Closed Meeting – Westinghouse AP1000 Reactor Coolant Pump Technical Update – October 29, 2014
(Non-Proprietary)

AP1000[®] Reactor Coolant Pump Technical Update

October 29, 2014

Tier 2 Section 5.4.1 – Preliminary

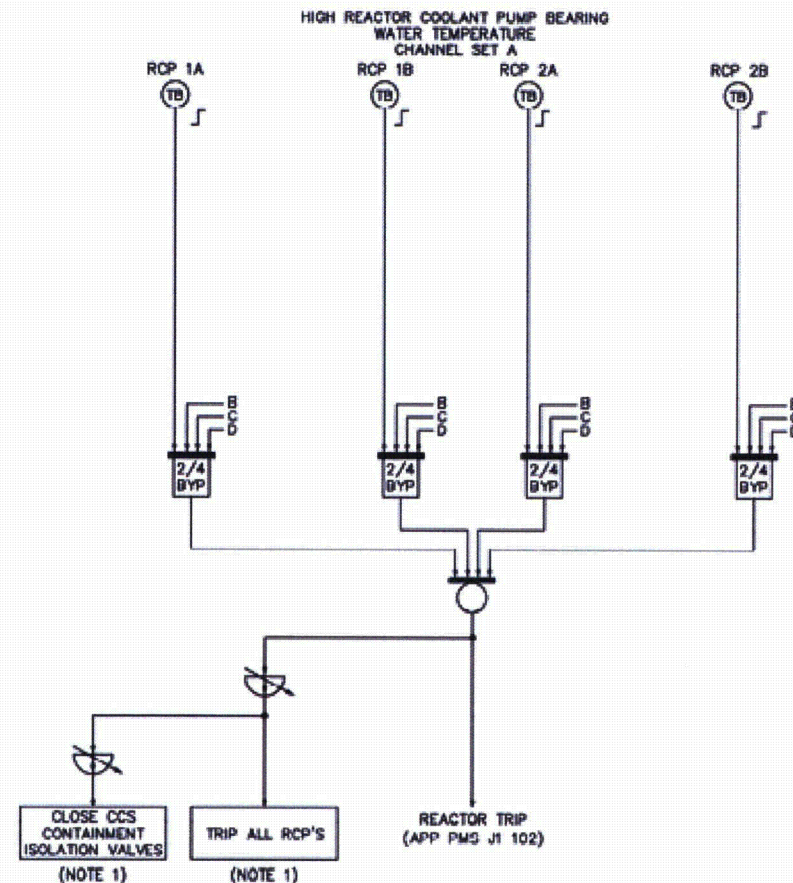
A loss of component cooling water has no impact on coastdown capability. The reactor coolant pump can operate without cooling water until a safety-related pump trip occurs on high bearing water temperature. This prevents damage that could potentially affect coastdown.
